A66 Northern Trans-Pennine project

Proposed changes consultation

January/February 2023

DC-01 – Change in speed limit west of M6 Junction 40

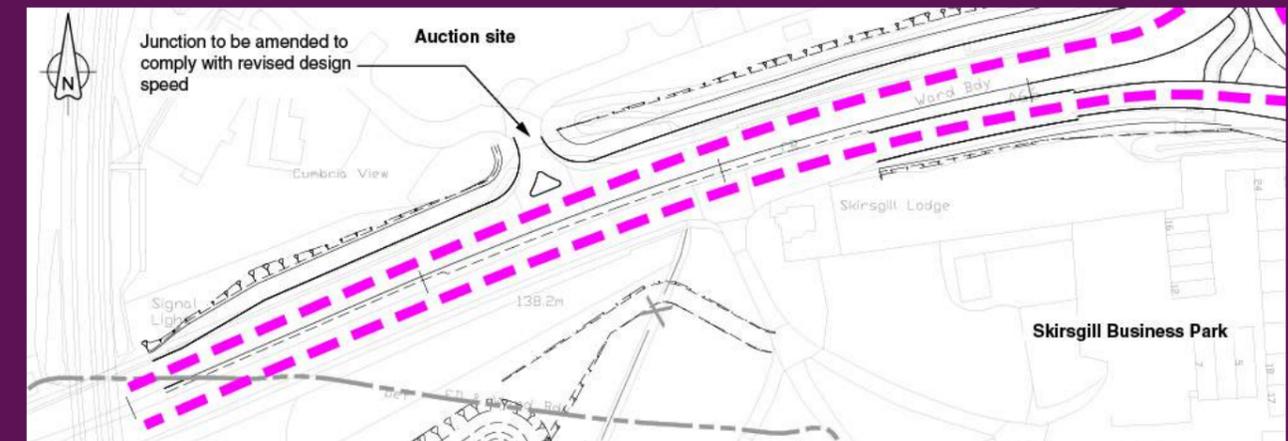
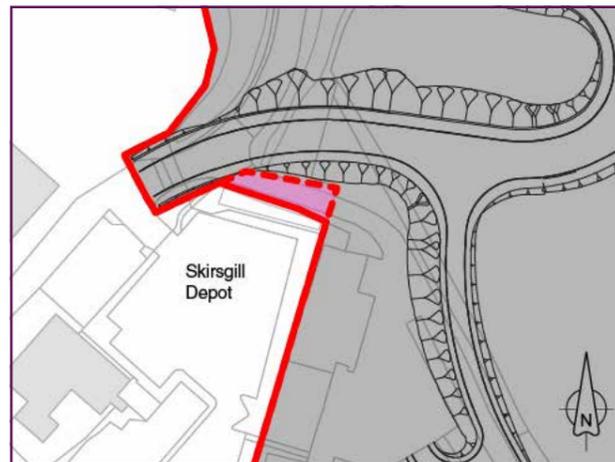
Our proposed change would reduce the speed limit from 70mph to 30mph on both the eastbound and westbound carriageways of the A66, between the railway bridge and Junction 40. As a result, there could be no need to add merge and diverge lanes to the auction site access. A more compact junction arrangement (similar to the existing access) would be safe and suitable.

This change would make the shared cycleway safer and reduce the speed of eastbound traffic passing the entrance/exit to the auction site as it approaches the roundabout at Junction 40 of the M6. The more compact arrangement for access to the auction site would be more in keeping with the existing access and would reduce our impact on the landowner and the auction business by reducing the land required.

This design change would help to reduce the area of carriageway/hard standing required. This could shorten the construction programme, simplify the drainage and signage arrangements and reduce the amount of materials needed for construction.

DC-02 – Realignment of walking and cycling route at Skirsgill

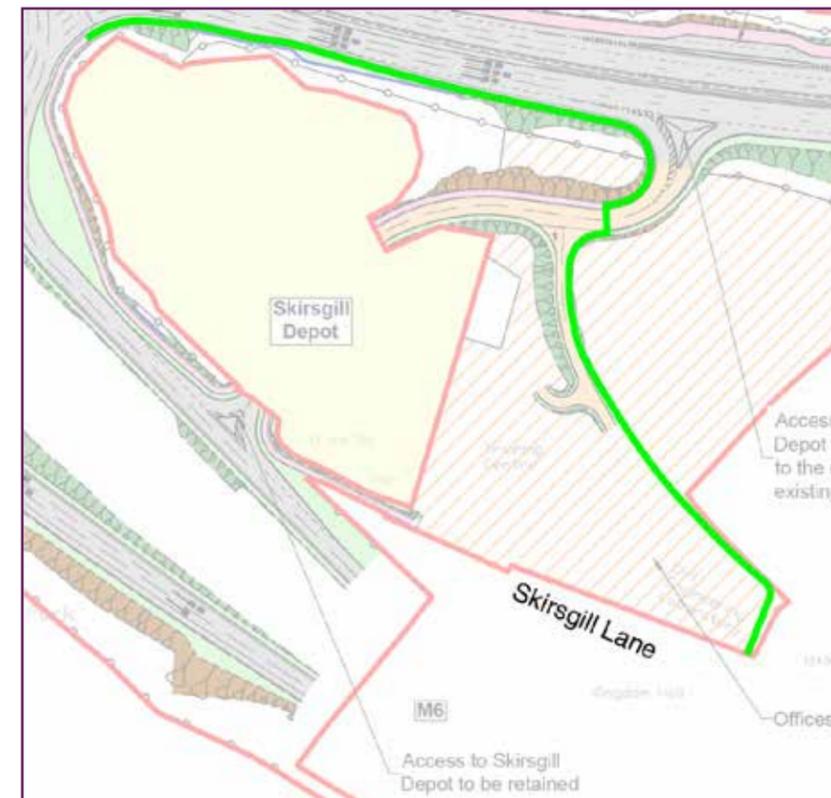
This change proposes that we divert the footpath from the slip road and re-direct it alongside the boundary of the Skirsgill depot to the north. Pedestrians and cyclists will take a route which runs adjacent to the A66 before heading south east to join Skirsgill Lane.

In addition, earthworks on slip roads are heavily constrained in this location meaning that structural solutions may be required to retain the route.

The re-routed footpath will reduce the earthworks required and shorten the duration of the construction programme. The exact location of the walking and cycling route, as well as the access arrangements, will be developed further during detailed design, in conjunction with Cumbria County Council.

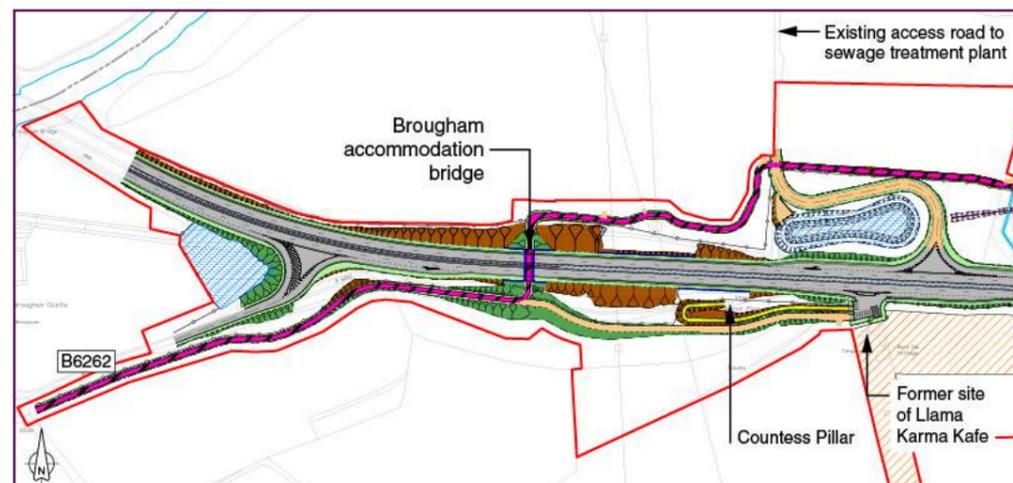
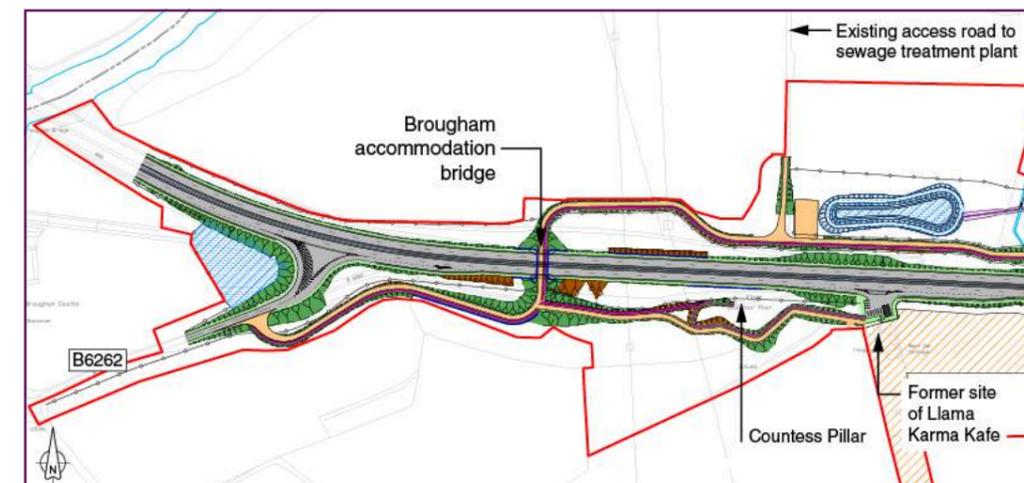
Our proposed change is to provide a private access track, shared with a cycle track, from the north side of the A66, crossing the A66 on a bridge and continuing to the B6262. This replaces what was put forward in the DCO application for access to the eastbound carriageway. On the southern side we would retain access to the Countess Pillar.

By removing the junction, we avoid a clash with the gas pipeline and reduce potential disruption and the risk associated with the road being built over nationally significant utilities which would make ongoing maintenance both unsafe and costly.

With this change, access to the A66 is provided to the westbound rather than the eastbound carriageway. In the DCO design drivers would turn around at Center Parcs to travel west and with this change, drivers would need to use the junction at Kemplay Bank to travel east. The distance to Kemplay Bank is

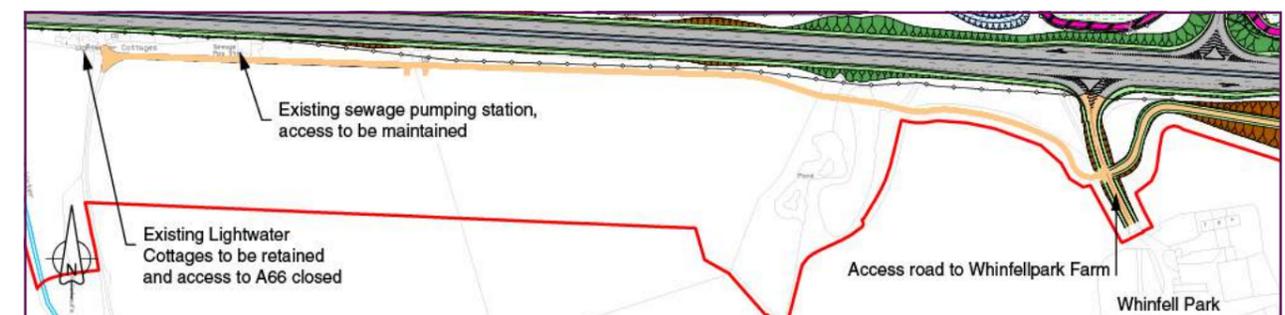
The proposed change retains Lightwater Cottages and removes the direct access onto the A66 for Haversheaf Hall.

The proposed change is in response to concerns raised by Eden District Council about the demolition of Lightwater Cottages and the shortage of rented rural accommodation. The tenants of Lightwater Cottages had also raised similar concerns about the shortage of accommodation in their response to our autumn 2021 consultation.

By preserving the cottages people would be able to stay in their homes. This change also supports the principle of the development of the A66 to minimise access points along the route in order to reduce the volume of vehicles entering and leaving fast-flowing traffic on the newly-dualled sections of the route and so makes it safer.

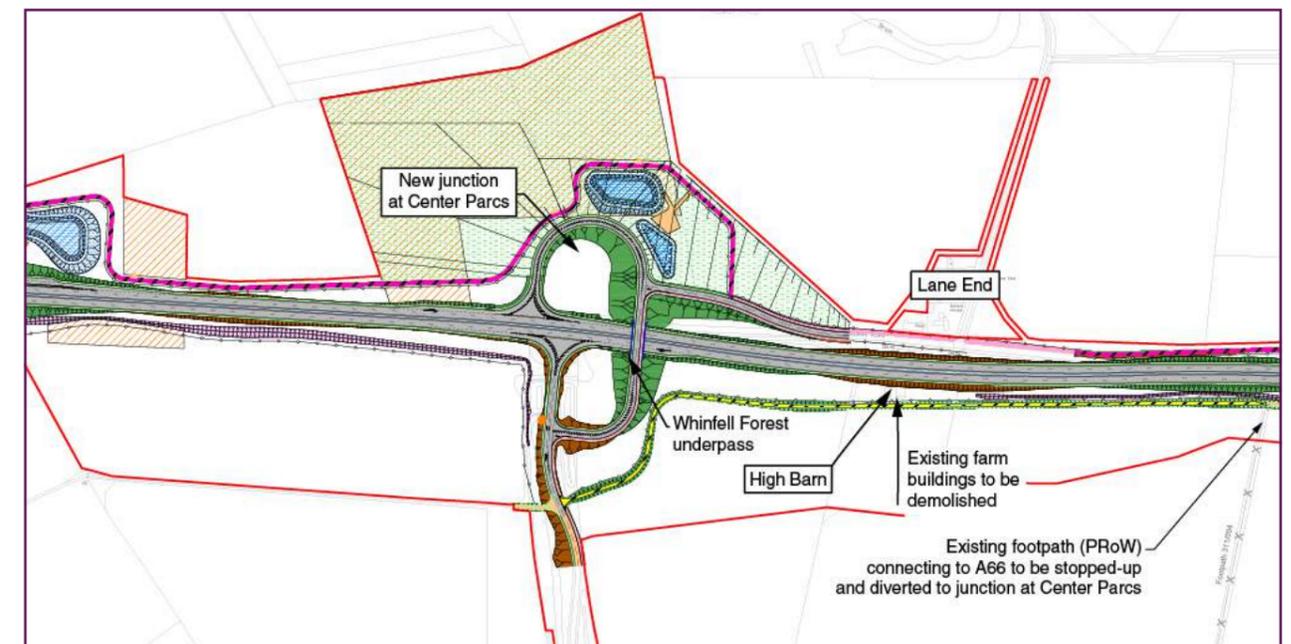
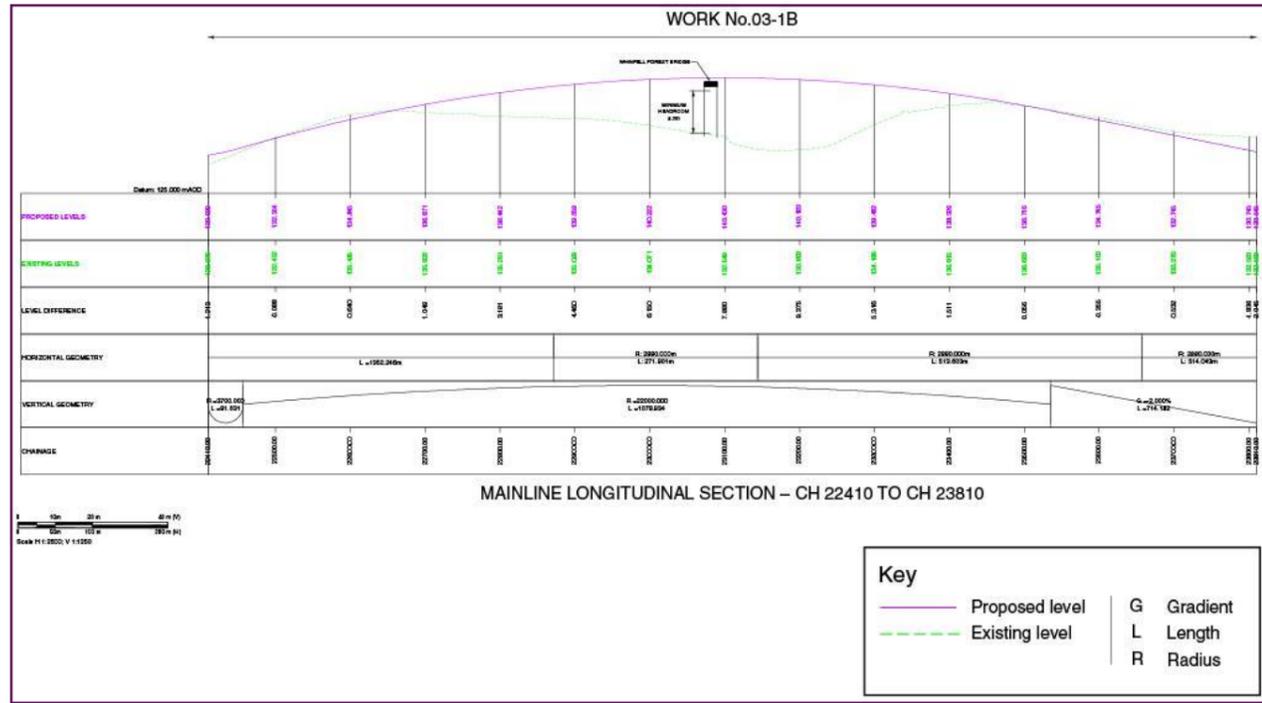
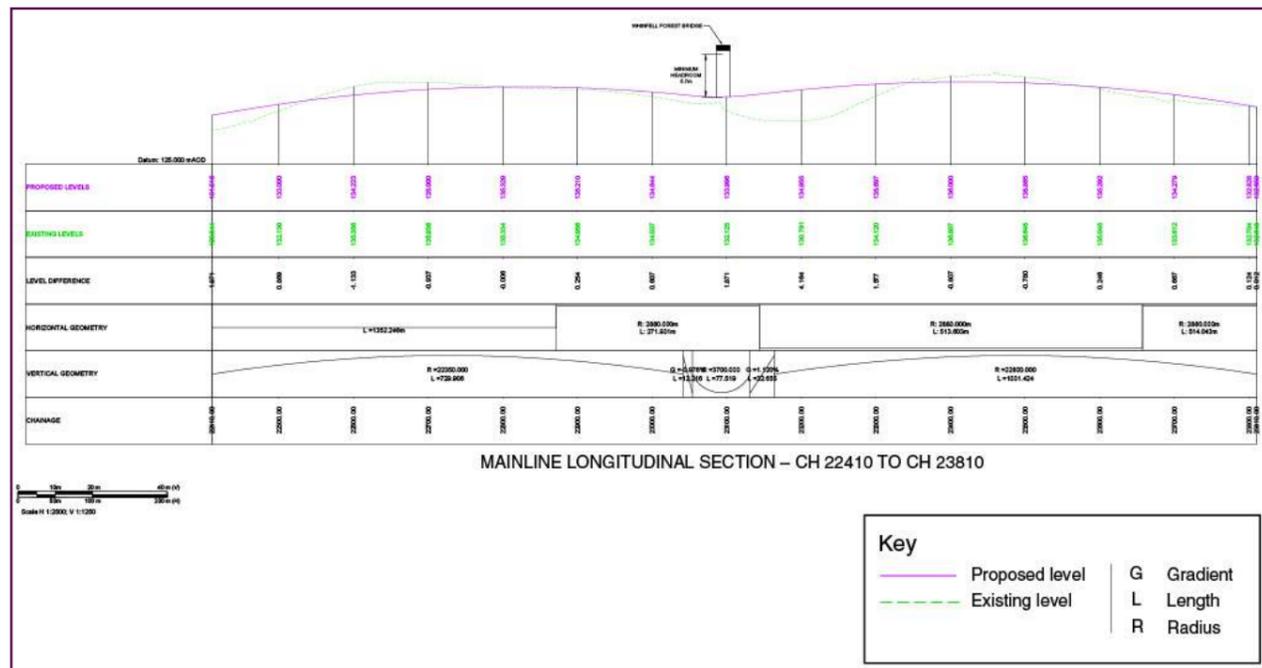
The proposed change removes the need for the temporary diversion, which would have been around 1.2km, minimising disruption for road users. The new bridge would be built in two sections with traffic initially being retained on the existing A66 while the westbound carriageway and southern half of the structure is constructed. Once complete, traffic will be switched to the newly-built carriageway whilst the northern half of the structure and eastbound carriageways works are completed. This will substantially reduce the construction period and amount of temporary work in this location as well as reducing construction traffic.

This would also remove the need for large earthworks which, due to soil disturbance, would impact on the productivity of the surrounding land for some time to come and would require a high number of vehicles to transport material. It would also reduce the overall land required for the project.

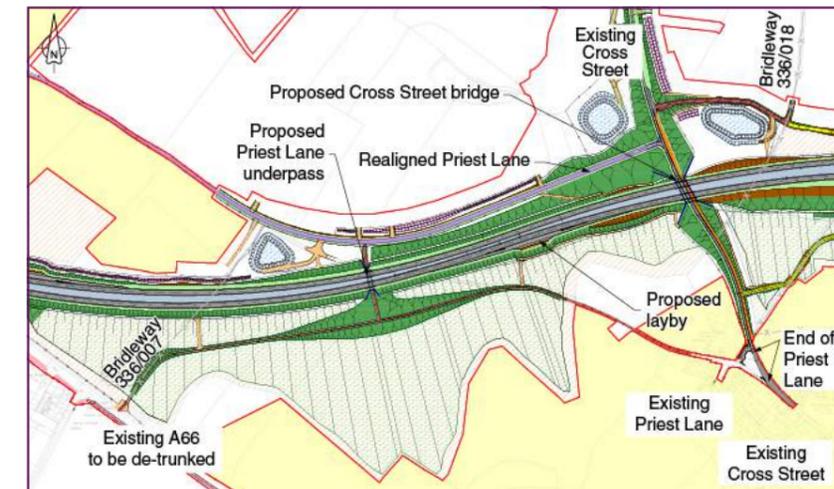
We propose to no longer provide the Priest Lane underpass and redirect both WCH and the landowners requiring access to their farmland via Cross Street.

Our proposal to remove the underpass enables the shared brideway to be raised closer to existing ground levels, meaning landowners would retain more land for farm use as the size of the earthworks required for the brideway will be reduced.

As a result of early detailed design it was determined that the underpass would require lighting. By removing the underpass we remove any potential impacts of the lighting in a rural area whilst there would be a reduction in construction works associated with electrical supply to the underpass.

DCO design (inset shows walking route between Cross Lane and Fell Lane)

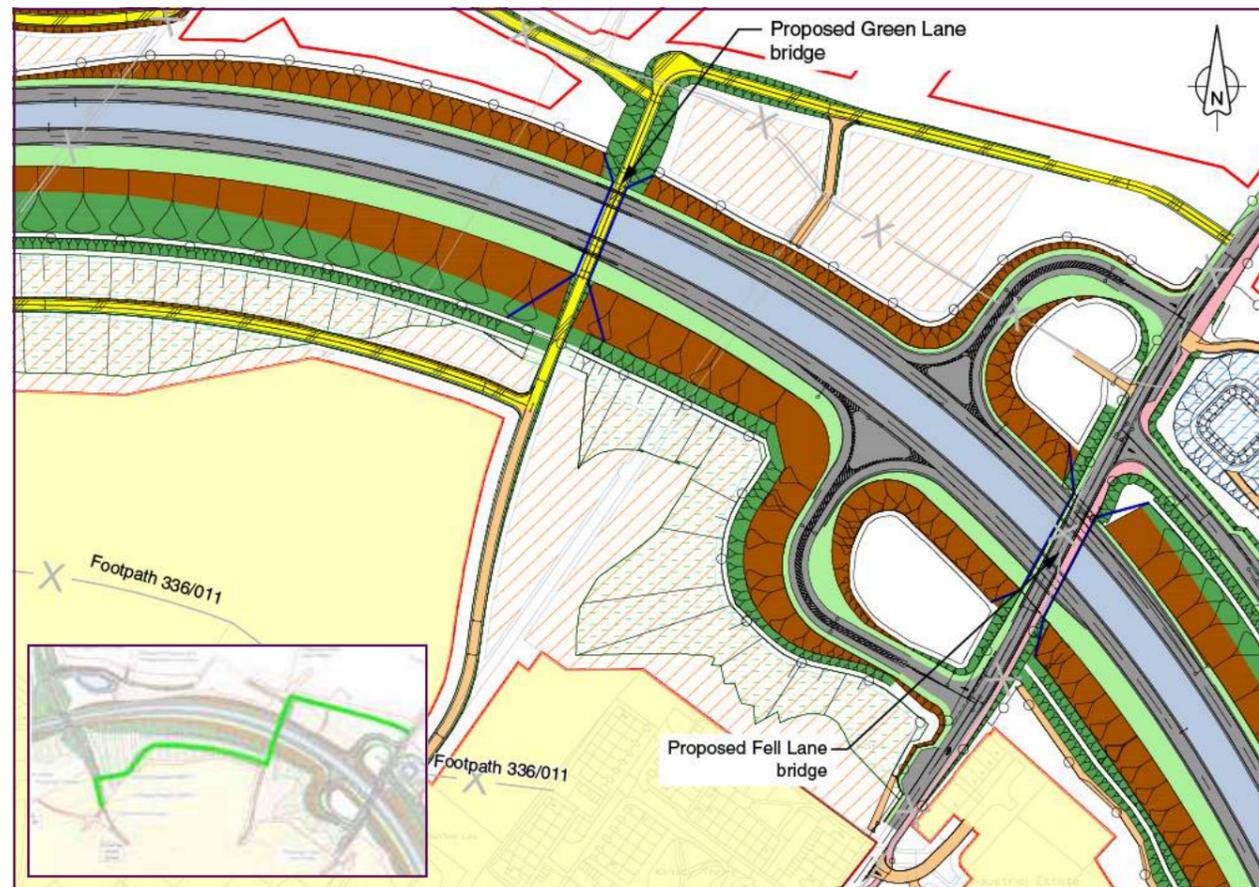
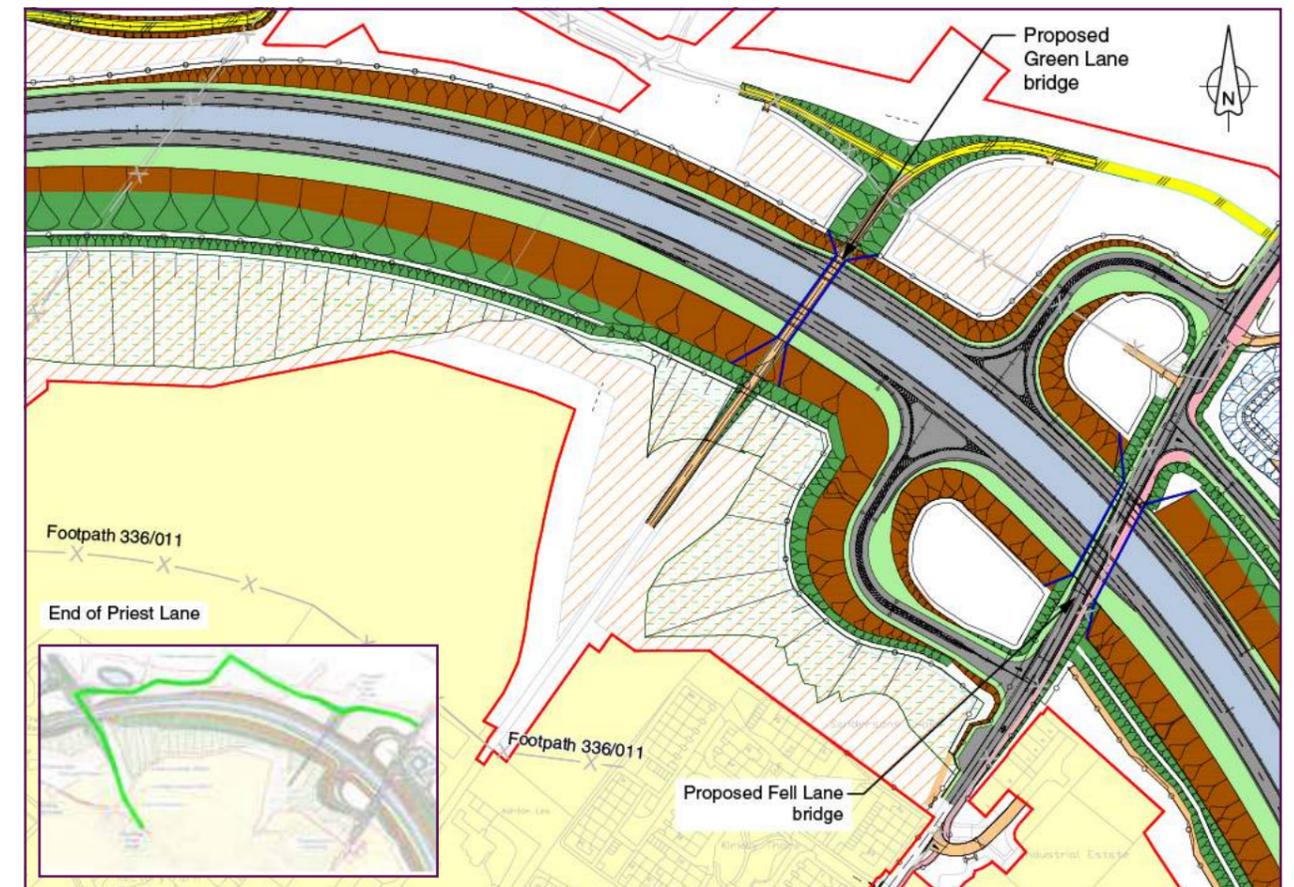
The change we are proposing is to make Green Lane bridge a private access track, meaning only the landowner will use it. Walkers, cyclists and horse riders (WCH) will be able to use Cross Street or Fell Lane to reconnect to the

We are also proposing to move the bridge back to the original alignment of the current farm access track rather than the current designed location which cuts diagonally across the field. This change has been discussed with the landowner who is in agreement with the proposed change.

This change means the width of the bridge would be reduced as it now serves only one purpose.

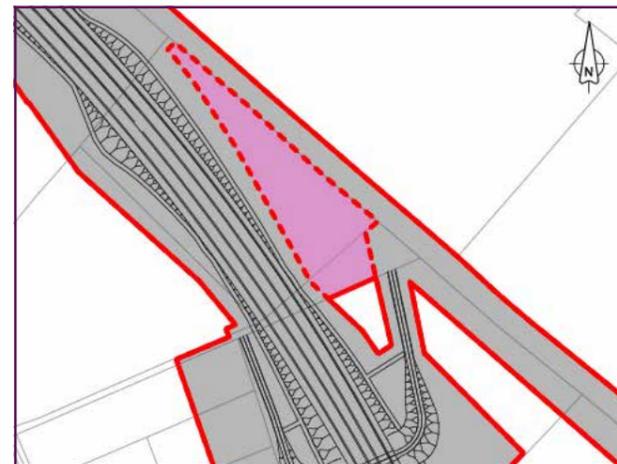
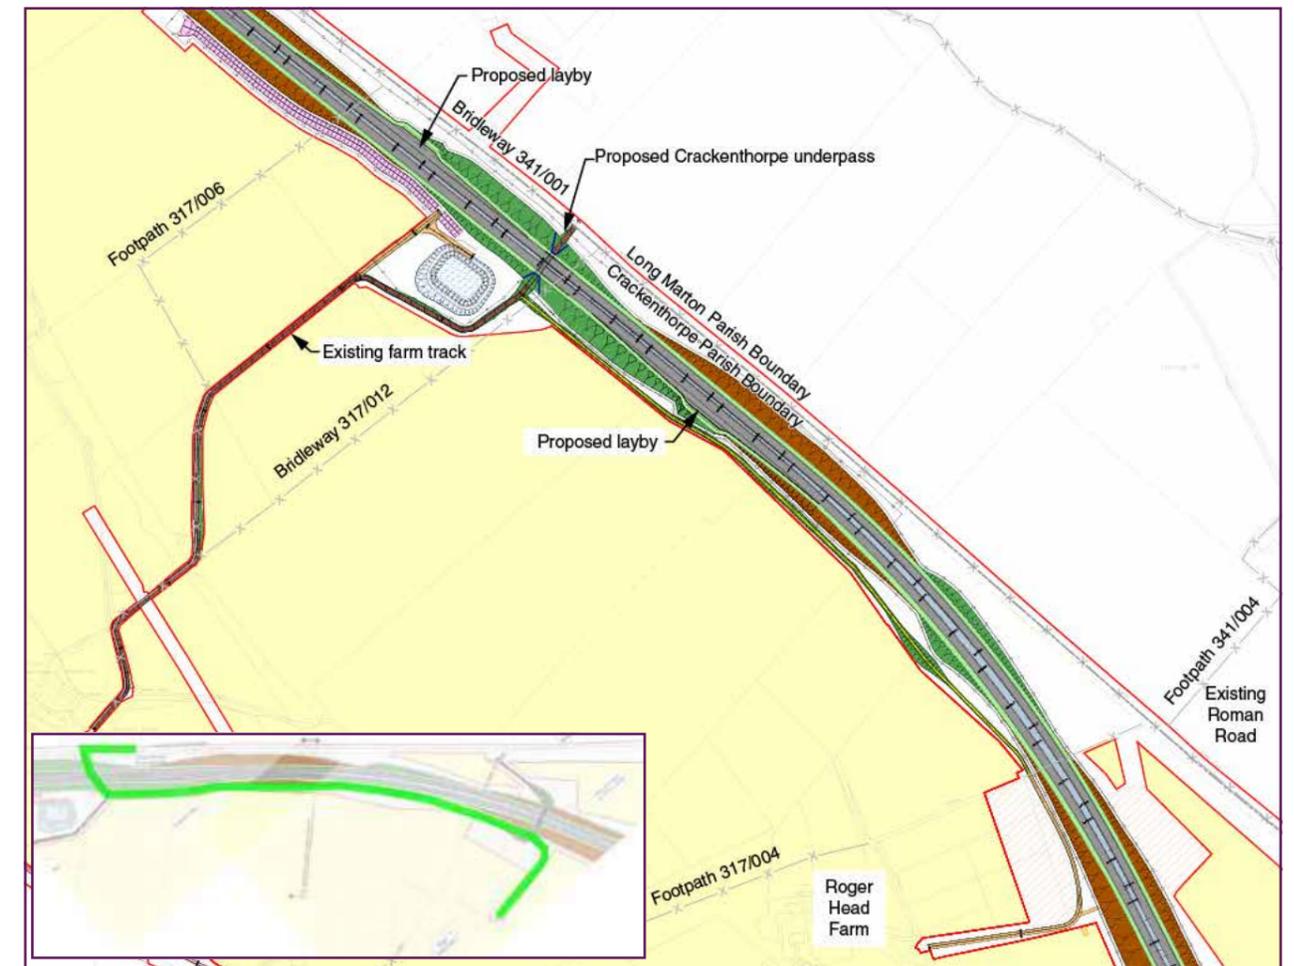
The proposed change is to no longer construct the Roger Head Farm bridge and instead divert the severed footpath, parallel to the A66 on its southern side, to an underpass 700m to the west. The underpass will provide access under the new A66 and connect to an existing bridleway on the Roman Road to the north west.

A small parcel of land is now isolated by this change. This will be included within the Order Limits, with the intention of using this for environmental mitigation.
